Williams Appeal of County Planning Commission Denial of Williams Accessory Dwelling Units

Case Nos. 21APL-00000-00024, -25, and -26

Appeal by George and Karen Williams

Santa Barbara Board of Supervisors

3rd Appeal Issue Raised

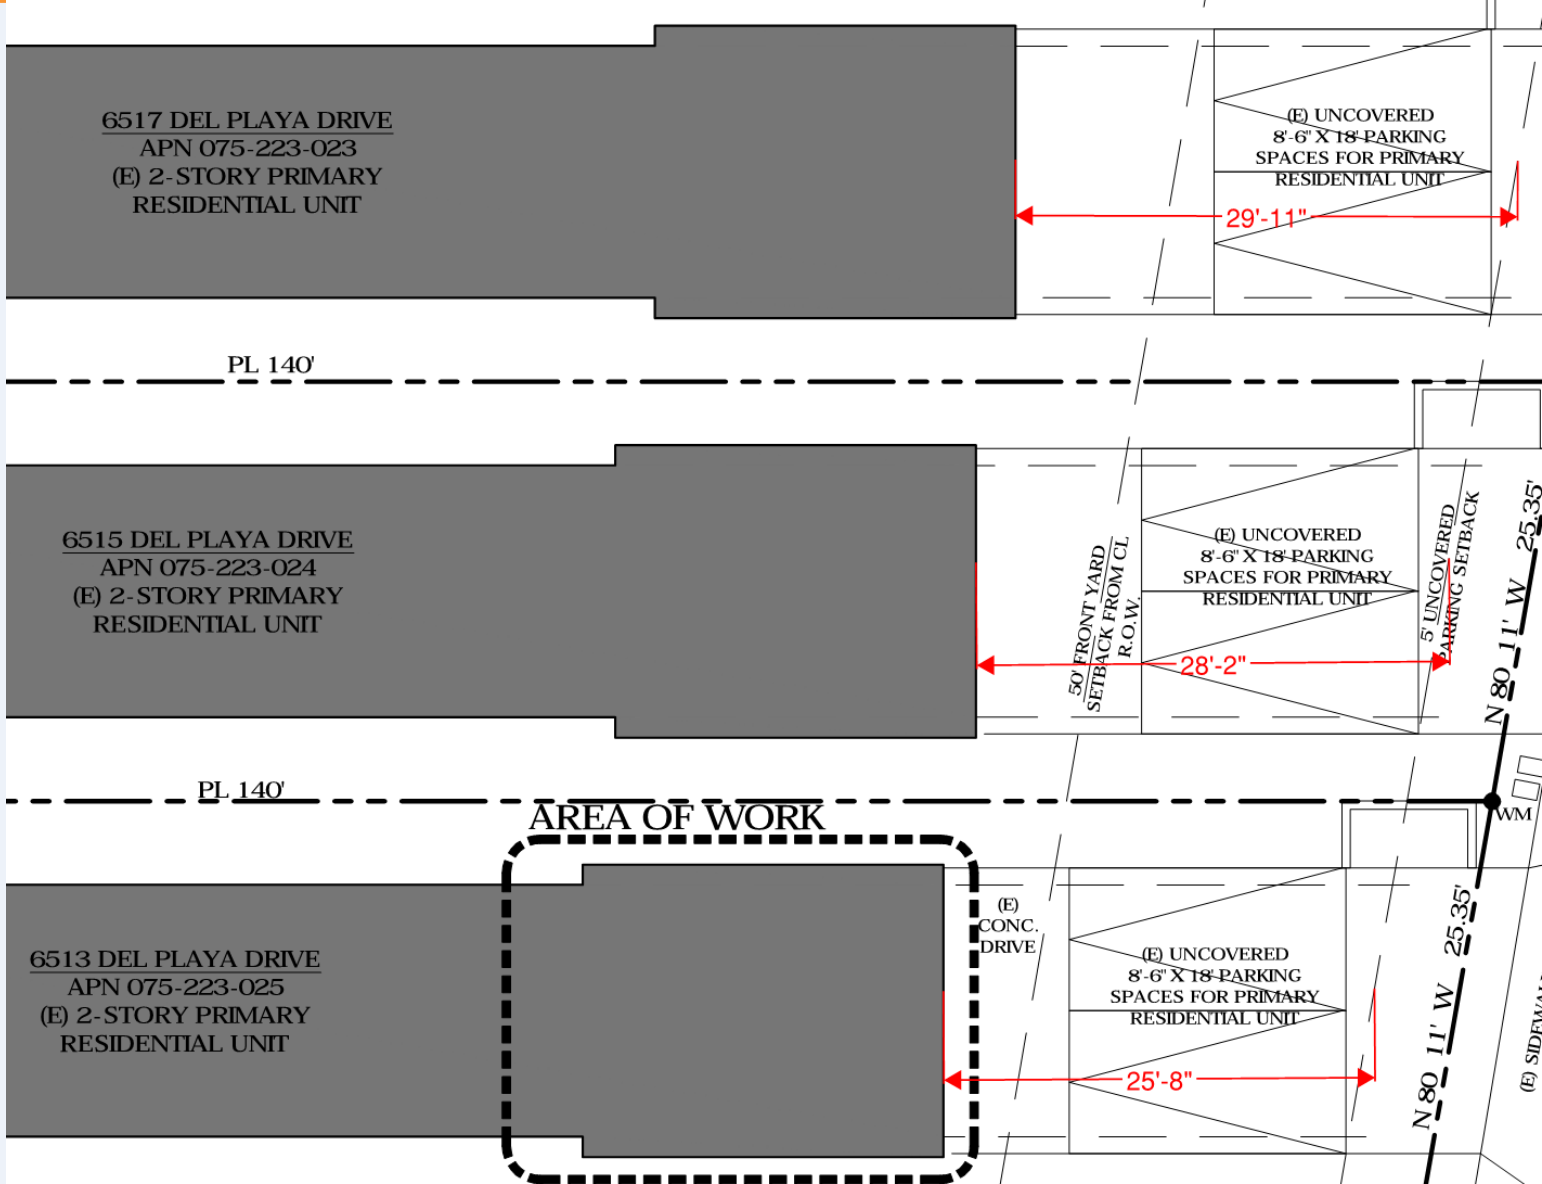
- Assertion:
 - Each driveway, if cemented, can easily accommodate four cars in tandem without infringing on sidewalk
- Staff Response:
 - Parcels do not have space to accommodate tandem parking arrangement while complying with required 5-ft minimum distance from edge of Right-of-Way
 - Need between 31' and 33' to accommodate tandem parking
